Subject: Acknowledgement of the Intent of City staff to appeal the preliminary FIRM maps released by FEMA.

Project: Watertown Preliminary FEMA Risk Maps

Subject: Watertown Preliminary FEMA Risk Map Comments

Lake Kampeska Gage Elevation from 2017 to 2024 with Datum Information

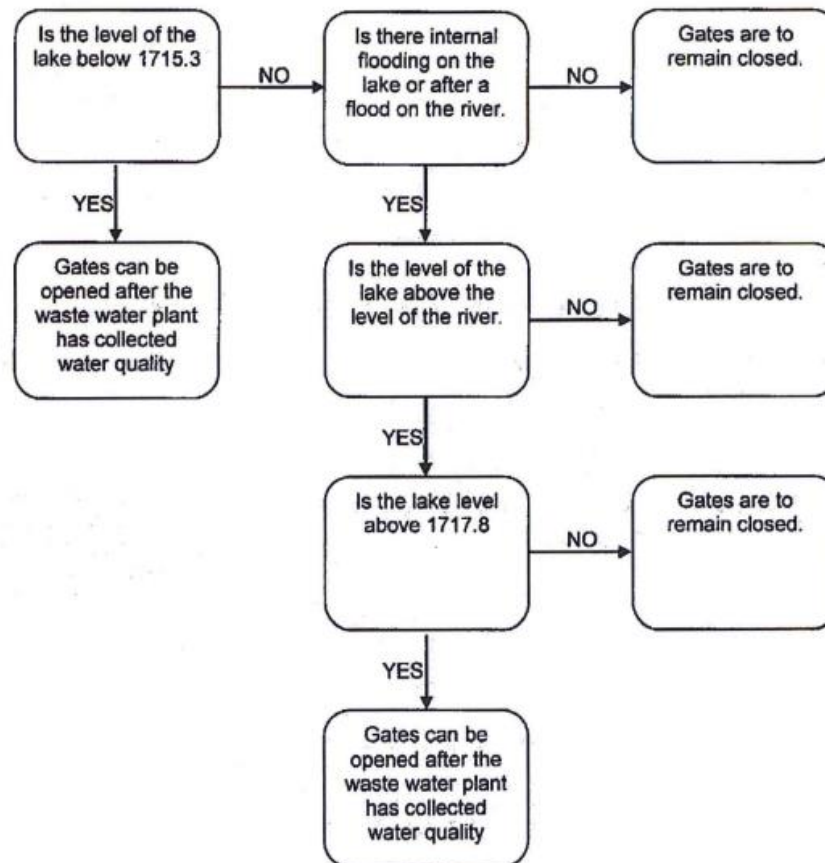
3. **Lake Kampeska Water Elevation:** The starting water elevation for Lake Kampeska appears to be modified by the modeling team in the model terrain because the model terrain is well below the LiDAR terrain water elevation. The lake elevation in the model terrain, elevation 1716.25 ft (NAVD88), is 2.7’ below than the weir elevation in the model, and the weir elevation is the structure that regulates the water elevation in the lake.

Gage data for Lake Kampeska from 2017 to 2024, as shown in the screen clip below, shows that the lake elevation has never been near elevation 1716.25 ft (NAVD88) (gage height 15.26), and for a significant period of time the water was above the weir elevation.

team should review the lake operation and revise the starting water elevation on the lake to be 1718.8 ft (NAVD88) which represents the top of weir elevation.

Lake Kampeska Weir Location Not Modeled

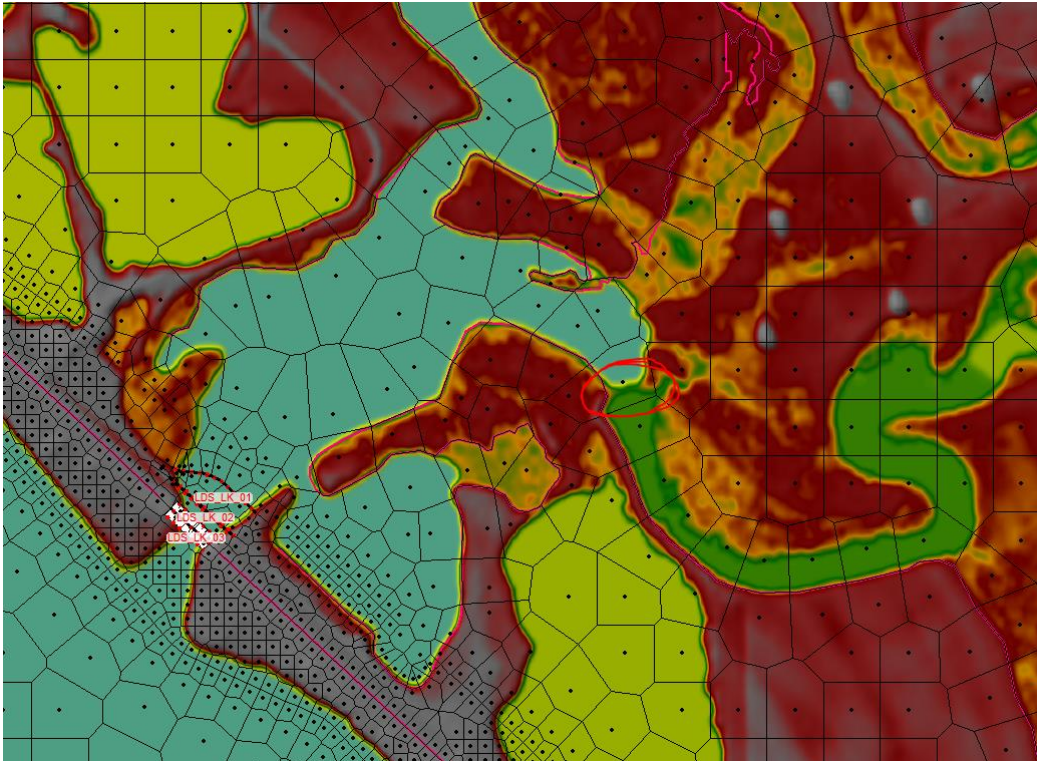
5. **Lake Kampeska Downstream Weir:** There is a weir downstream of Lake Kampeska on the Big Sioux River that is not modeled in the HEC-RAS model. The weir location is shown on the screen clip below. The weir impacts the Big Sioux River water elevations at the Lake Kampeska/Big Sioux River weir. Negating critical weir structures on the Big Sioux River which helps establish the lake BFE causes the Lake Kampeska BFE to be inaccurate. Not taking into consideration a critical weir structure also does not follow the "Guidance for Flood Risk Analysis and Mapping: General Hydraulics Considerations" published by FEMA in 2016 which states that the impact of hydraulic structures should be considered.

Big Sioux River Downstream Leaky Cell at Weir Structure

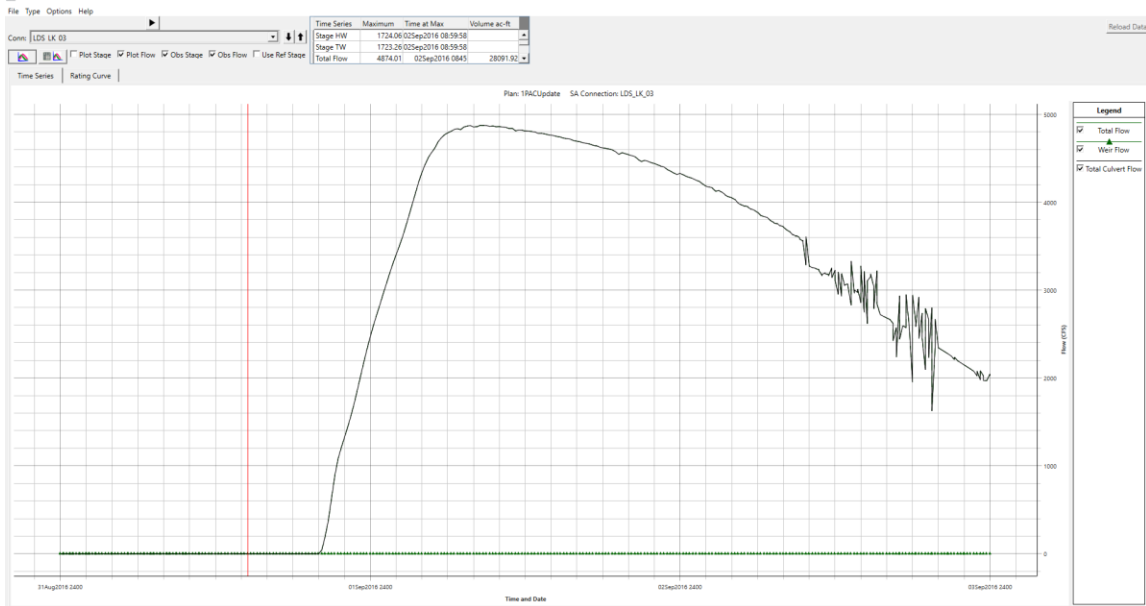
It should also be pointed out that at the location of the said weir, the modeling team developed a leaky cell across the said weir location which compounds the inaccuracy of the water elevations upstream on the Big Sioux River and Lake Kameska. When establishing BFE's in a detailed analysis, leaky cells should not be utilized since the leaky cells generate inaccurate results for water conveyance. The leaky cell is shown in the screen clip below.

Flow Hydrograph at Highway 20

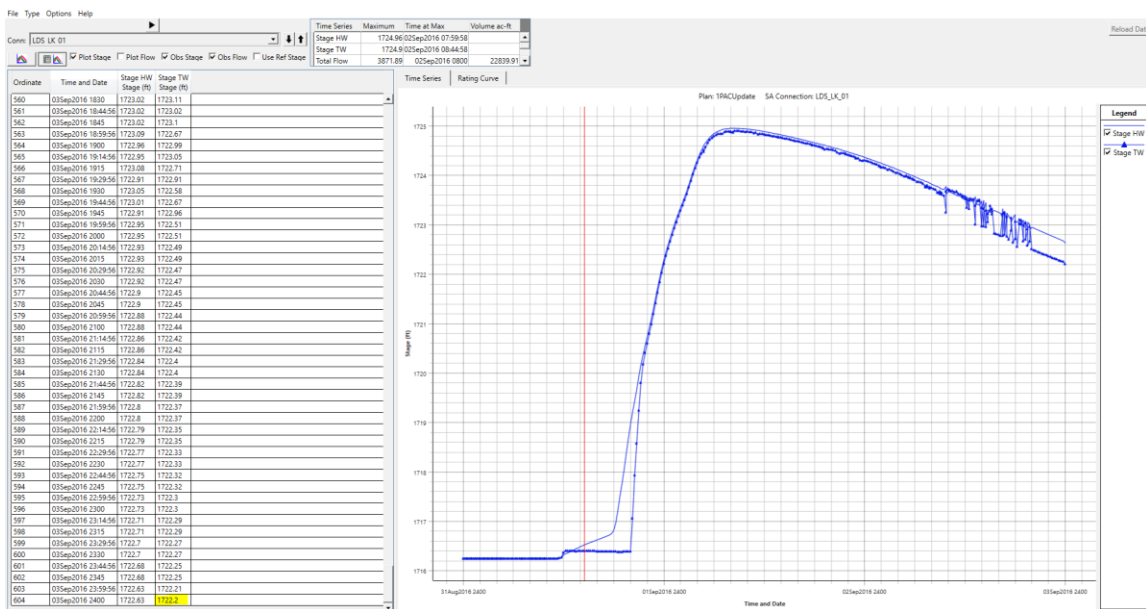
6. **Lake Kameska BFE:** The BFE established for Lake Kameska does not represent the peak water elevation of the lake according to the HEC-RAS model developed for the preliminary mapping. When reviewing the hydrographs results for flow entering Lake Kameska at the Highway 20 bridge, it is evident the modeling team ended the model run prior to Lake Kameska reaching the maximum BFE. The hydrograph shows that the lake is continuing to fill when the model run ended with approximately 2,000 cfs still entering the lake. The water elevation on the Big Sioux River side of the weir (1722.63 ft (NAVD88)) is higher than the Lake Kameska water elevation (1720.52 ft (NAVD88)) at the end of the model run which means water was still entering into the lake and the actual BFE will be likely higher than 1720.5 ft (NAVD88) as shown on the preliminary mapping.

Historical Lake Crests

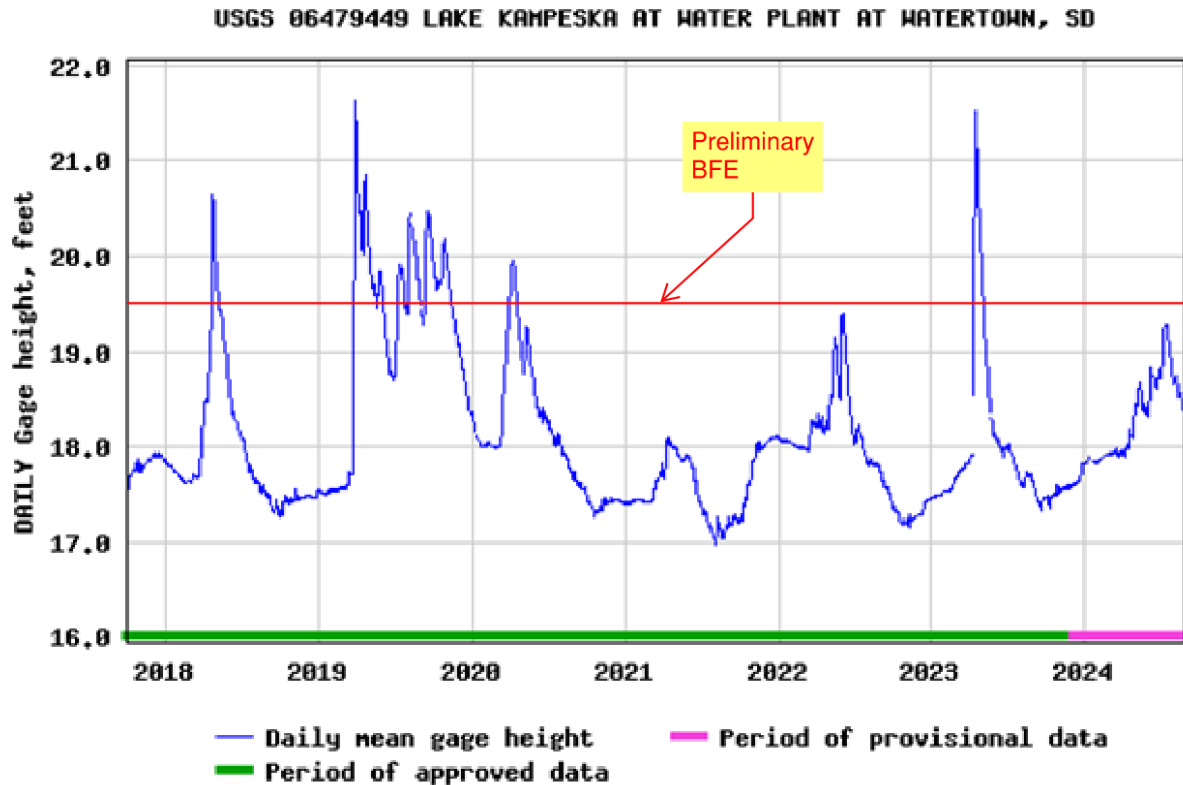
7. **Lake Kampeska BFE:** The BFE developed for Lake Kampeska (1720.5 ft (NAVD88)) does not appear to represent the statistical 1% lake elevation. Gage data at Lake Kampeska demonstrates that lake elevations have reached elevation 1720.5 ft (NAVD88) (gage height 19.51) or greater 9 times in the last 20 years. According to the preliminary mapping, residents have experienced 1% lake levels 45% of the time over the last 20 years. The historical crests for the lake are shown in the screen clip below.

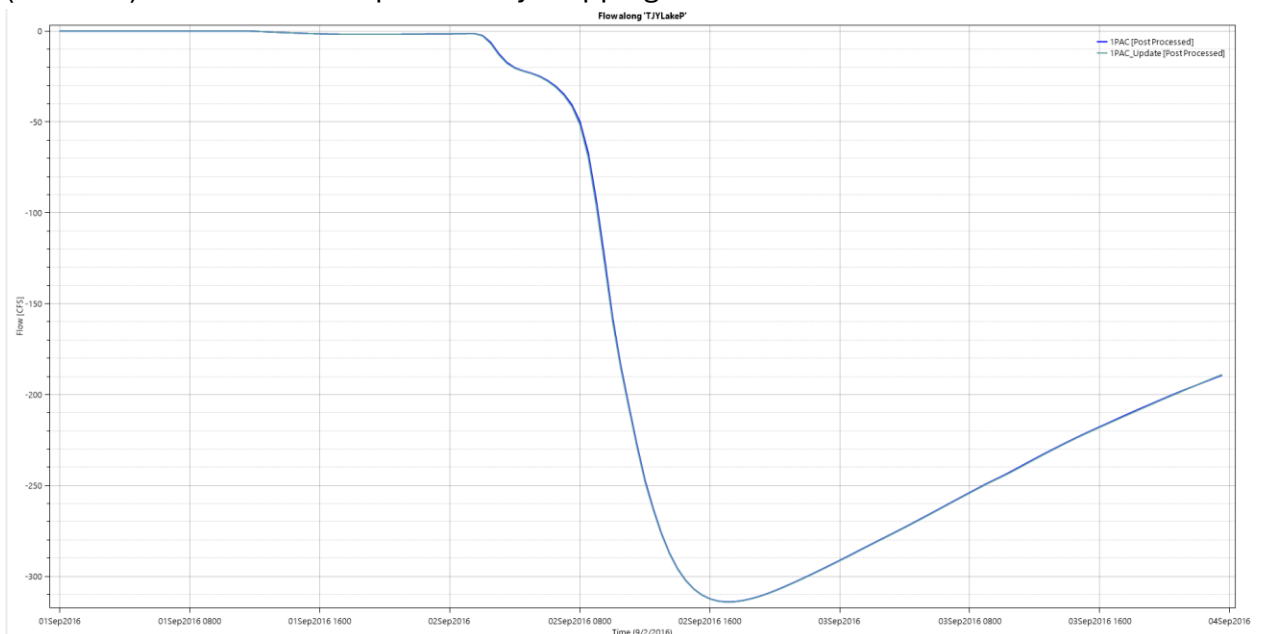
8. **Pelican Lake Water Elevation:** The starting water elevation for Pelican Lake appears to be modified by the modeling team in the model terrain because the model terrain is well below the LiDAR terrain water elevation. The lake elevation in the model terrain, elevation 1709.97 ft (NAVD88), is approximately 1.83' below the LiDAR water elevation 1711.8 ft (NAVD88). It was not apparent or documented how this elevation was determined. If the starting water elevation is below any normal water elevation for the lake, additional storage volume is provided for the lake which could create artificially lower BFE elevations for the lake; therefore, a normal water elevation for the lake needs to be established with this study. It appears the outlet for the lake is approximately elevation 1711.7 ft (NAVD88).

Pelican Lake Branch Structures

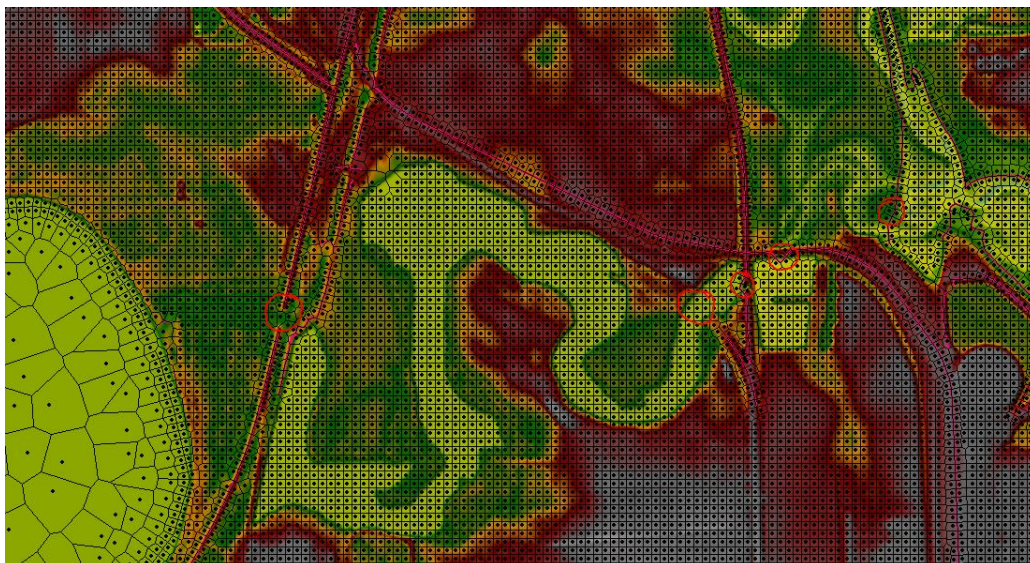
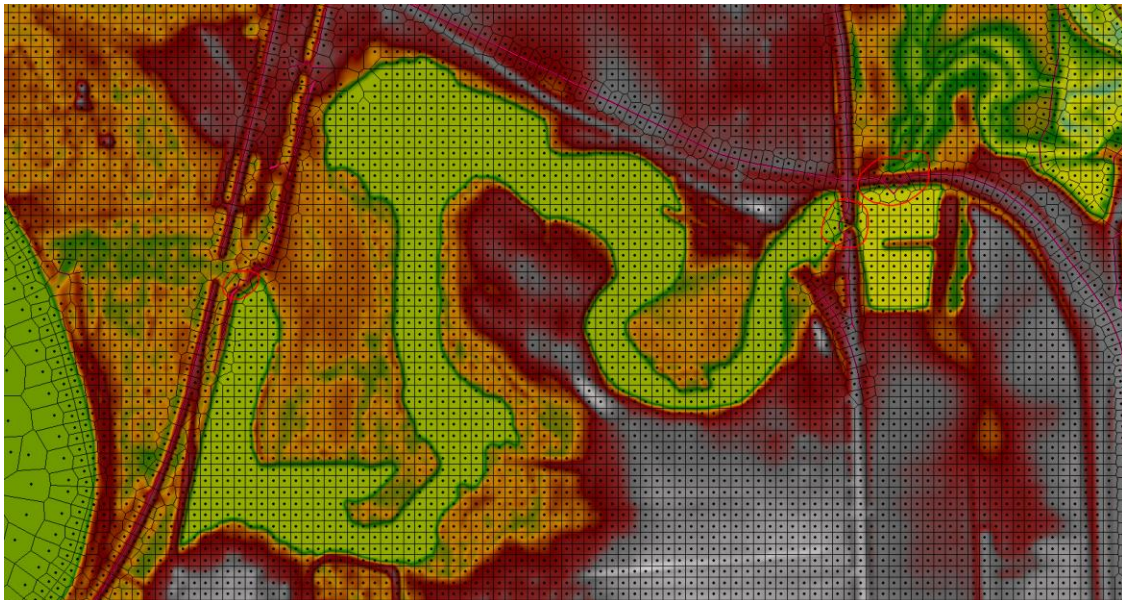
10. Pelican Lake Branch Structures: Pelican Lake Branch is identified as a Zone AE with floodway. The floodway has 5 structures associated with this reach, as shown in the screen clip below, and none of these structures are modeled as shown in the next screen clip below. These structures are visible in aerial imagery, but not incorporated in the model. It appears BLE level detail was used in this reach, and no refinement was made for an enhanced study. Ignoring critical structures does not follow the “Guidance for Flood Risk Analysis and Mapping: General Hydraulics Considerations” published by FEMA in 2016 which states that the impact of hydraulic structures should be considered.

20th Avenue South Roadway Embankment

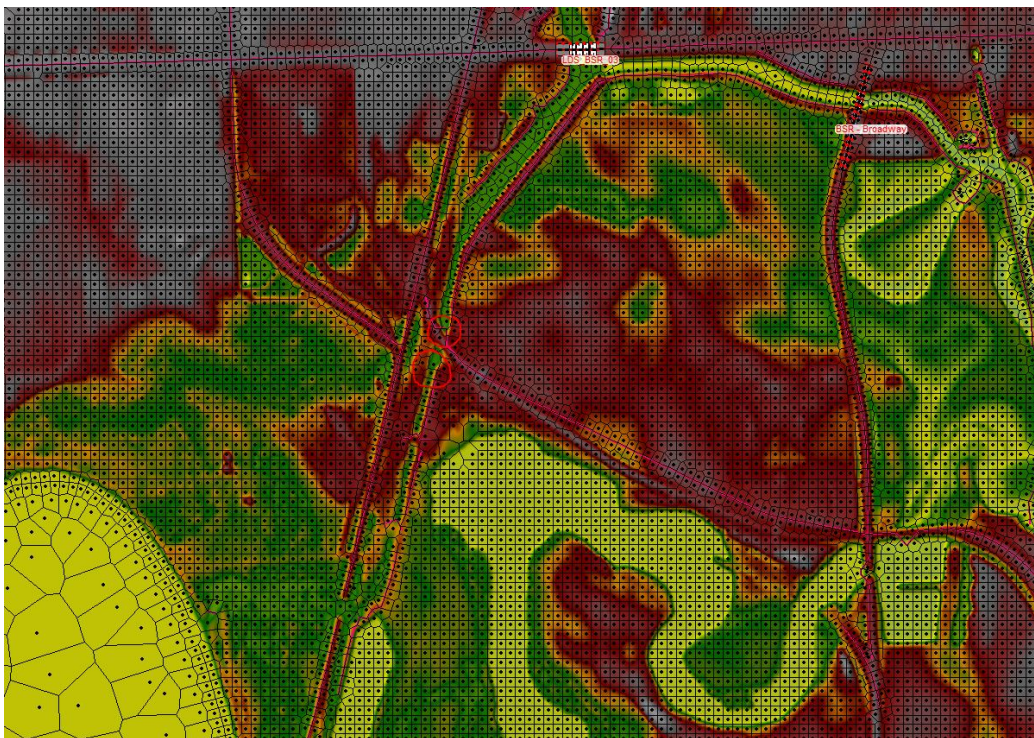
13. **20th Avenue South:** 20th Avenue South was constructed in 2012 and visible in aerial photography as shown in the clip below. The current modeling does not include the roadway embankment for 20th Avenue South which will have impacts on conveyance and water storage volume. As identified above, the roadway structures for the Pelican Lake Branch were also not incorporated into the model by the modeling team. The 2021 LiDAR captures the roadway embankment and should be used for by the modeling team for the preliminary mapping.

Tributary to Pelican Lake Branch Missing Structures

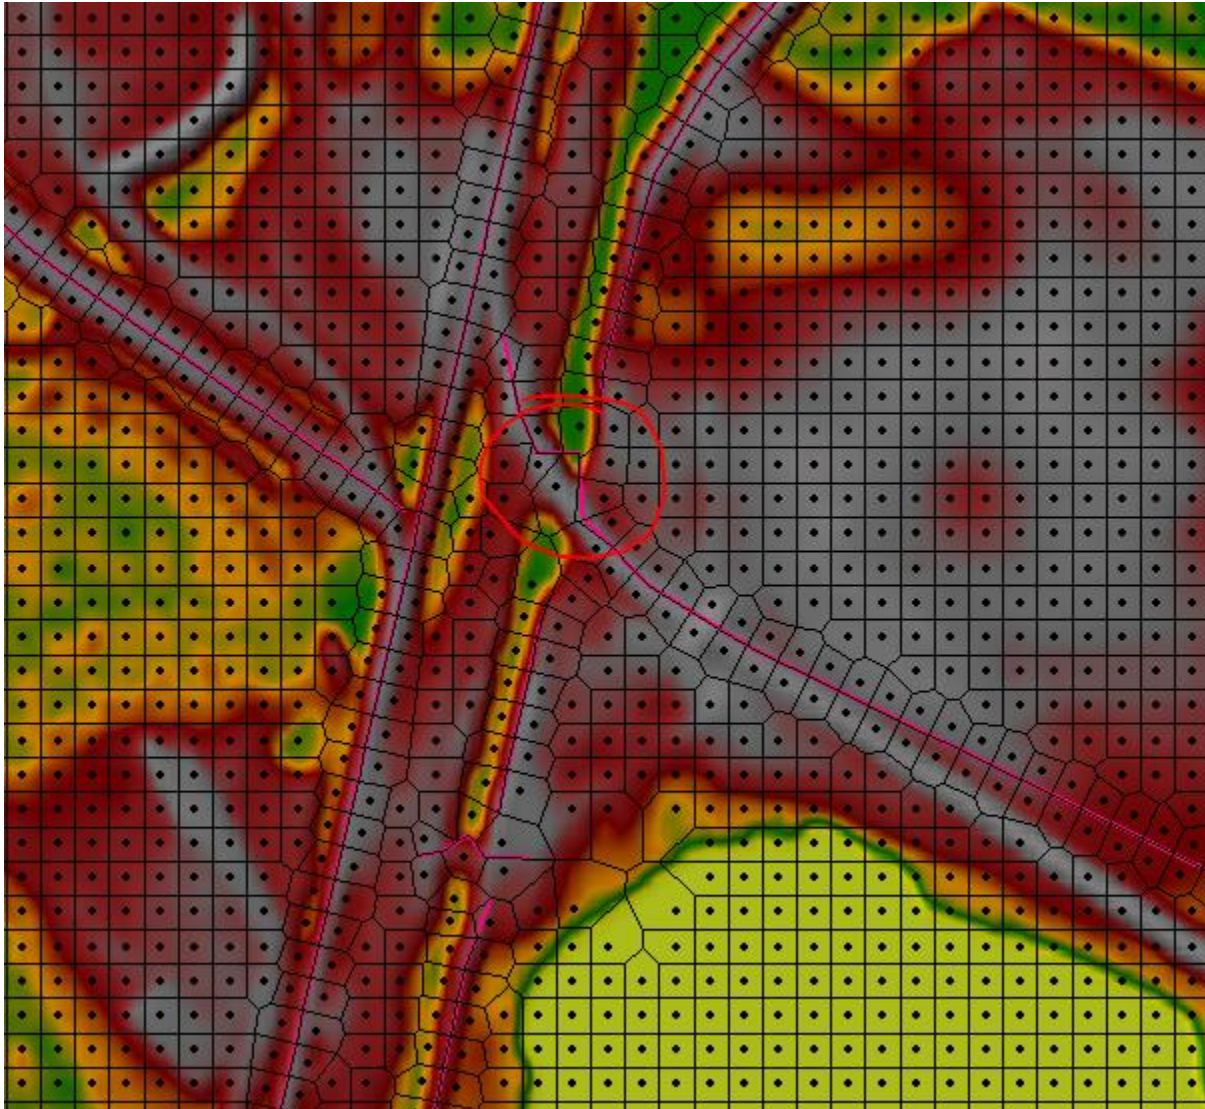
14. **Tributary to Pelican Lake Branch Structures:** Tributary to Pelican Lake Branch is identified as a Zone AE with floodway. The floodway has 2 conveyance structures associated with this reach, as shown in the screen clip below, and none of these structures are modeled as shown in the next screen clip below. These structures are visible in aerial imagery, but not incorporated into the model. It appears BLE level detail was used in this reach, and no refinement was made for an enhanced study. Ignoring critical structures does not follow the “Guidance for Flood Risk Analysis and Mapping: General Hydraulics Considerations” published by FEMA in 2016 which states that the impact of hydraulic structures should be considered.

Pelican Lake Branch Leaky Cells

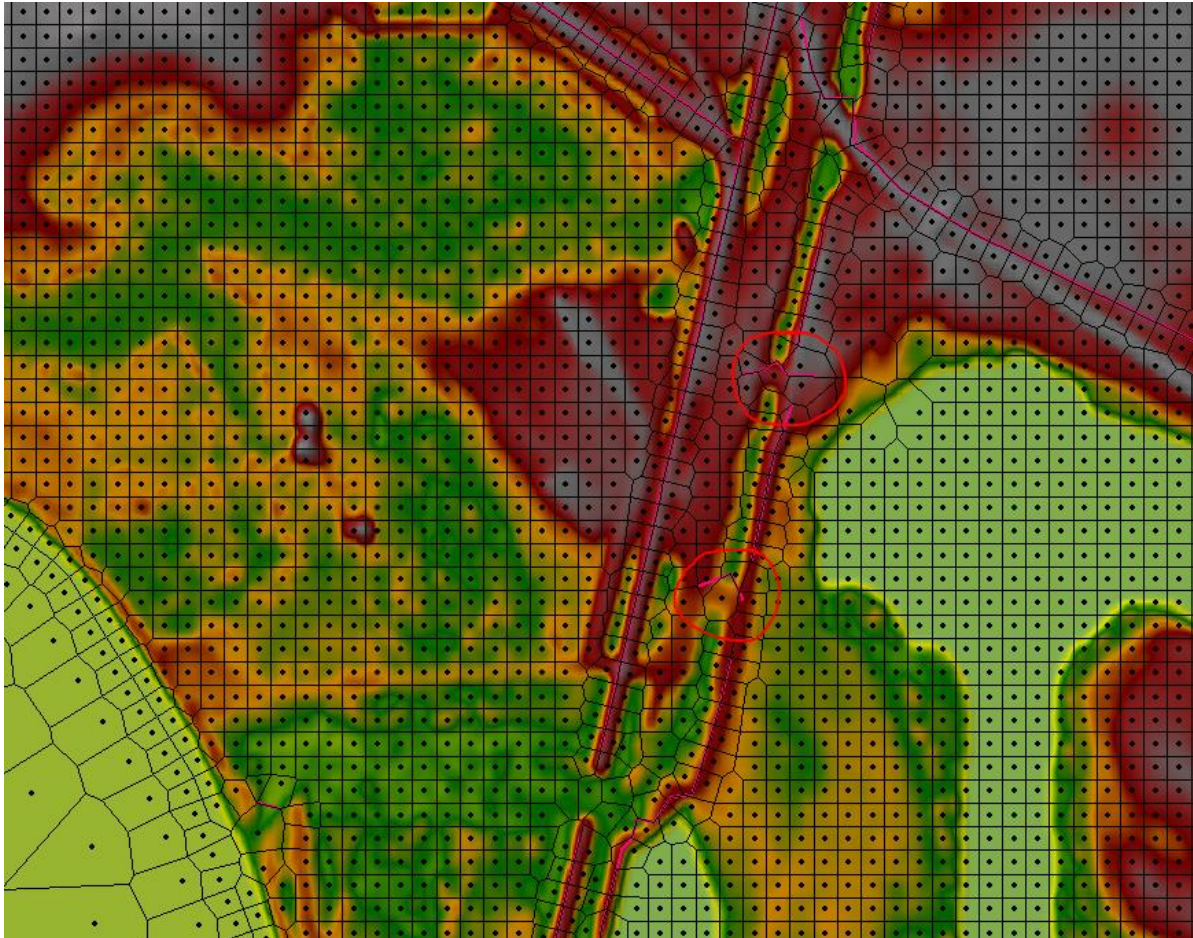
- 15. Tributary to Pelican Lake Branch Leaky Cells:** One of the two missing structure locations on the Tributary to Pelican Lake has a leaky cell at the crossings, the other location does not even show the 20th Avenue South roadway embankment. When establishing a Zone AE with floodway for a detailed analysis, leaky cells should not be utilized since the leaky cells generate inaccurate results for water conveyance. Example of the leaky cell is shown in the screen clip below.
